February 22, 2024

RE: Status of CU 24-01, DR 24-01, & ZA 24-01 "US Market gas station" at 2115 Molalla Rd (Tax Lots 051W09B001000, 1100, & 1200 [primary])

Staff reviewed the degree of completion of the Conditional Use (CU) consolidated applications package for the subject property with materials submitted January 23, 2024 and determined it incomplete as of February 22, 2024. Staff sends this letter to demonstrate compliance with Oregon Revised Statutes (ORS) [227.178\(2\)](#).

**LIGHTING PLAN**  
 A2.1 SCALE: 1" = 20'-0"  
 0' 2' 10' 20' 40'

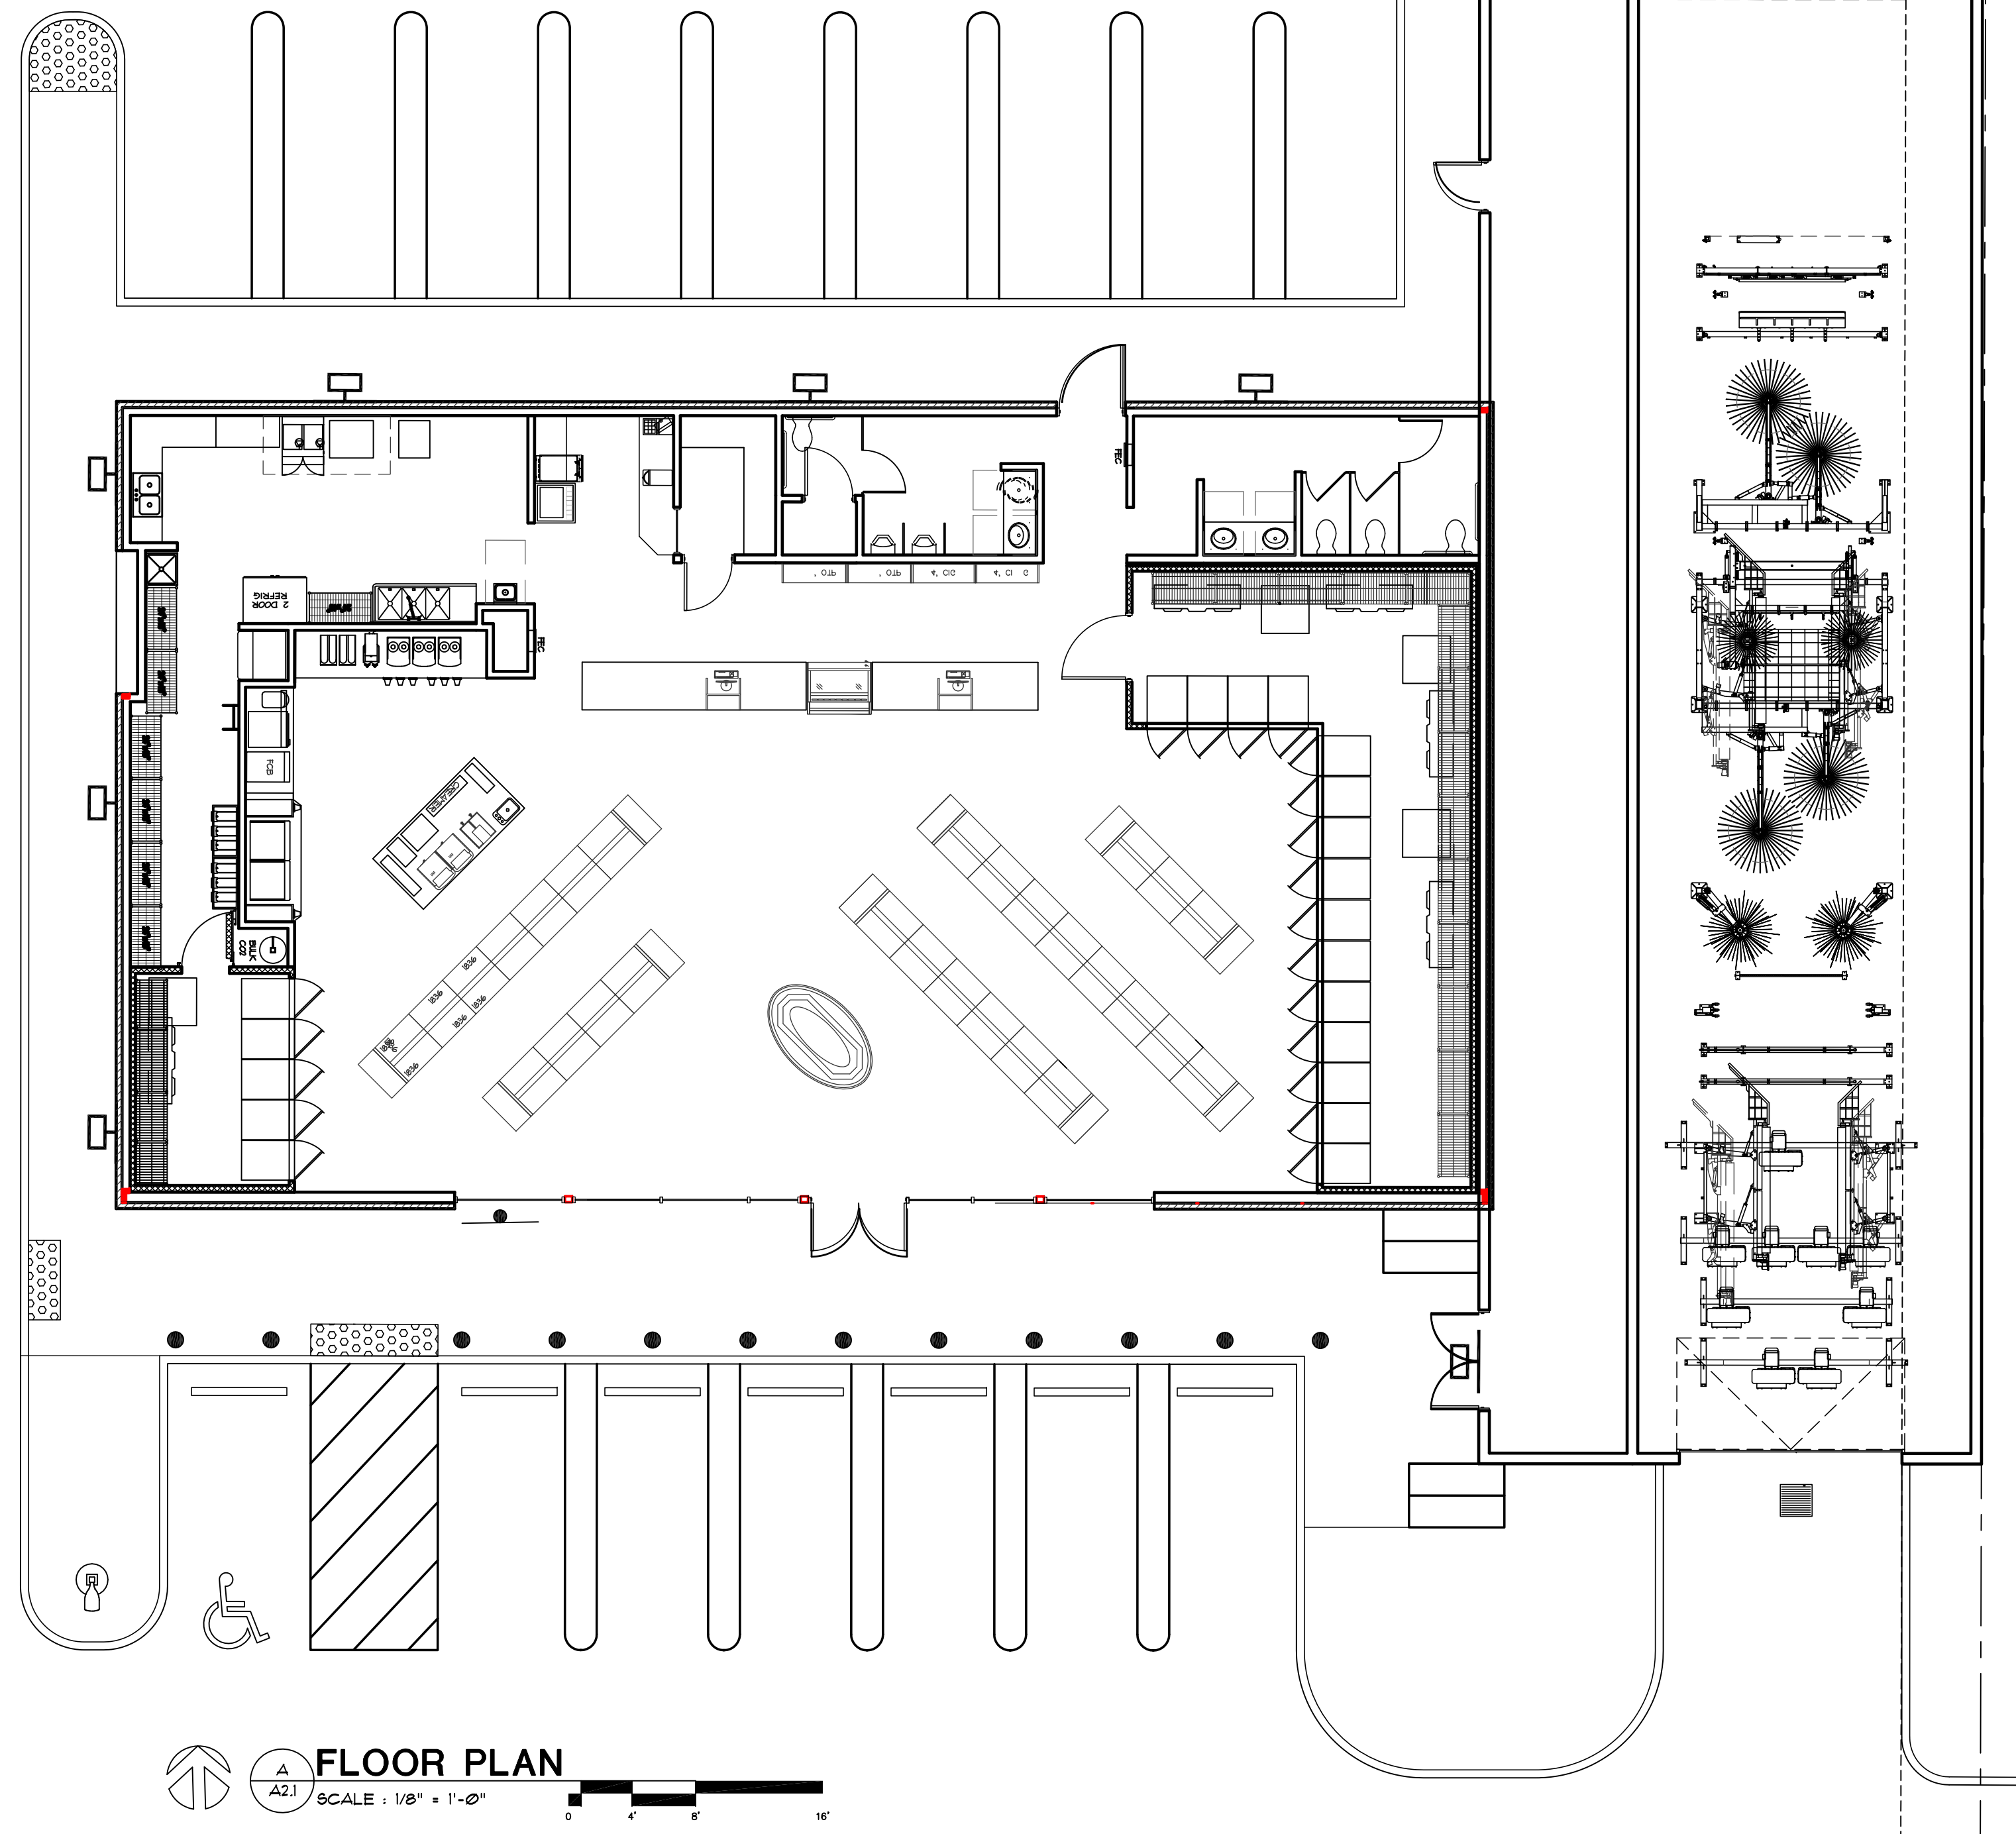
1. Revise the Sheet C105 photometrics plan, specifically the luminaire and pole schedule, to indicate how the vendor models conform to the hue / color temperature specification of 3.11.02C.
2. Submit cut/spec sheets for the vendor models.

**B CANOPY WEST ELEVATION**  
SCALE: 1/4" = 1'-0"

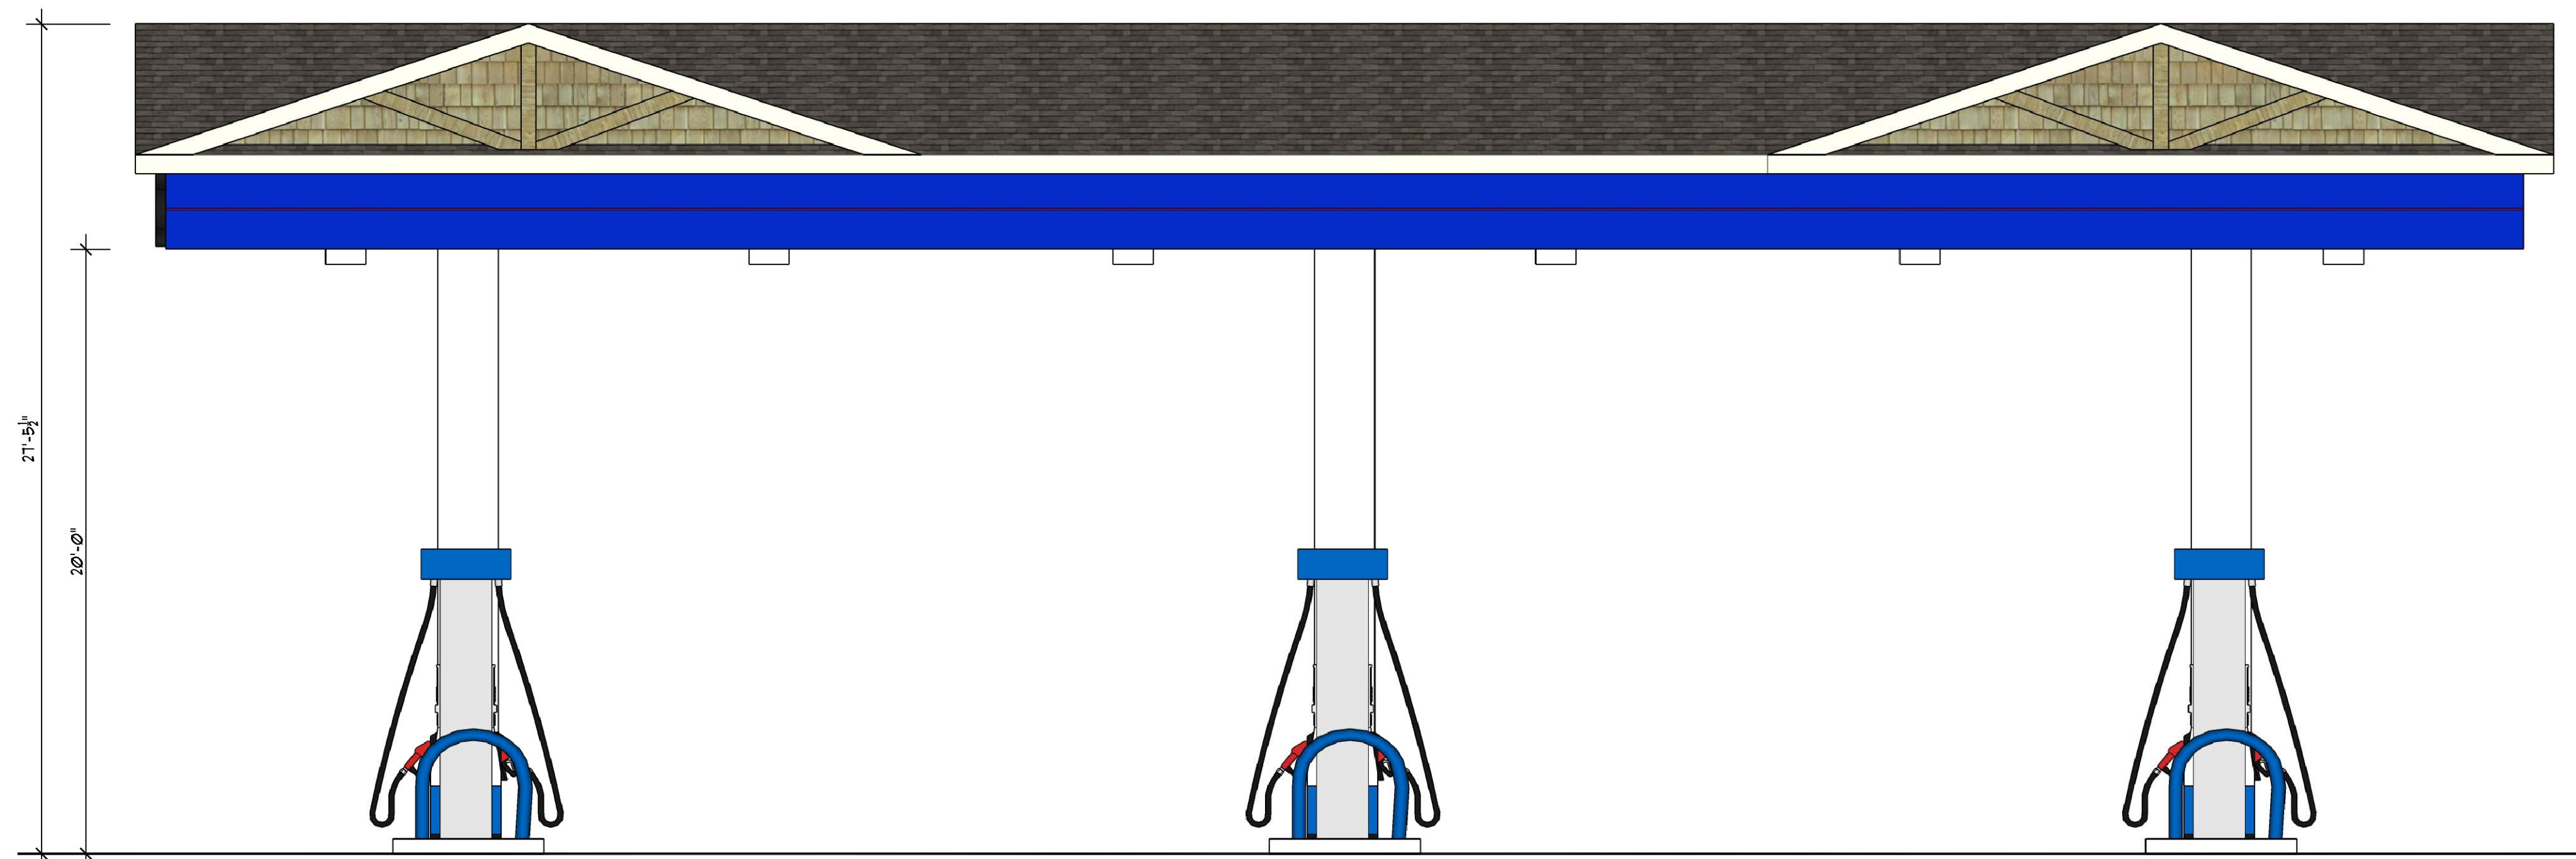
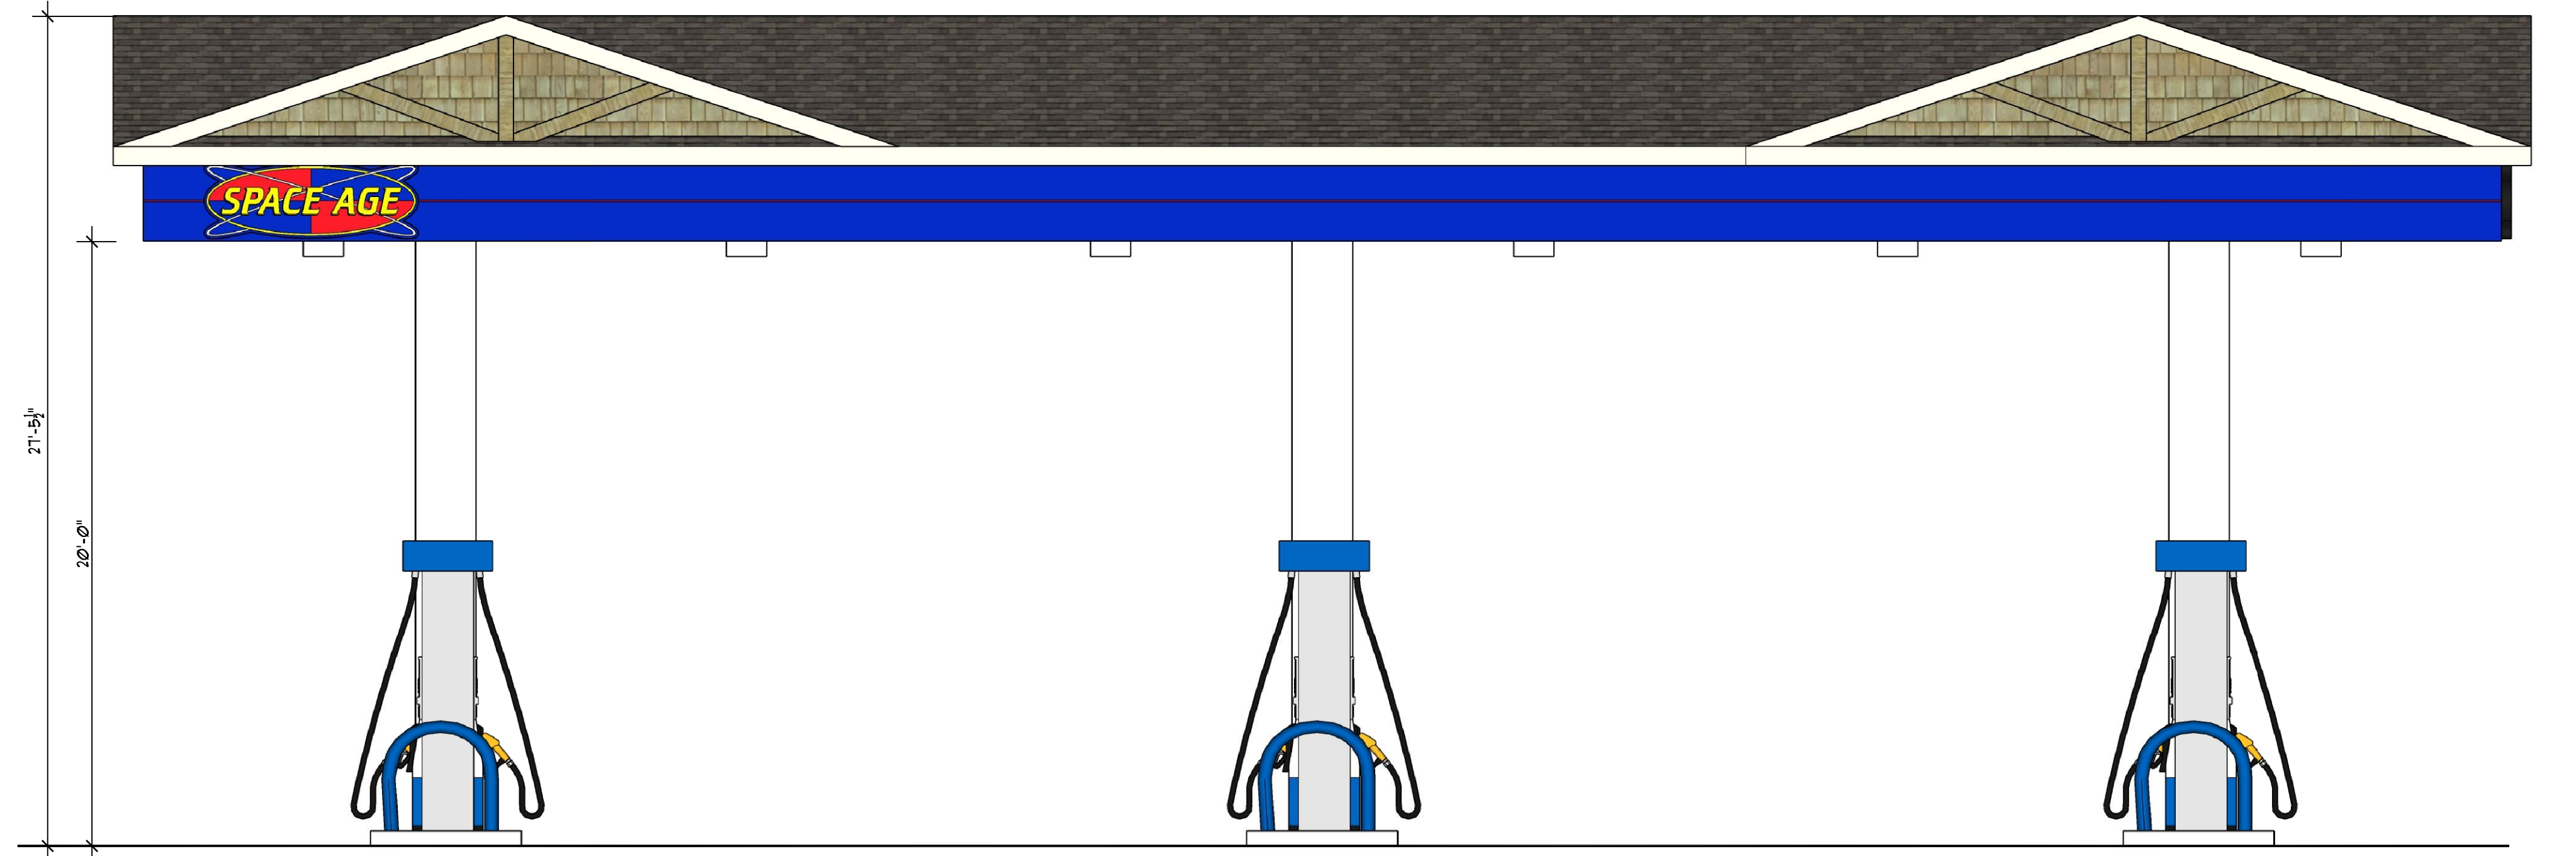
1. Awnings/canopies: Based on WDO 3.07.06B.1b(4) & B.5a, provide of any of a canopy, fixed awning, or roof overhang at the convenience store main entrance, minimum depth 4 ft, minimum width 9 ft, and minimum height clearance 9 ft:
2. Windows: Add 2:
  - a. 1, which could be translucent, on the convenience store west elevation, at least 2 ft narrowest dimension and at least approximately 8 square ft (sq ft).
  - b. 1, which could be translucent or spandrel glass, on the convenience store north elevation, at least 2 ft narrowest dimension and at least approximately 8 square ft (sq ft), ideally aligned with the west gable end.
3. Lighting: Revise the convenience store west wall-packs from 3 to 2.
4. Gas pump canopy: Revise the elevations to indicate maximum height 16 ft.
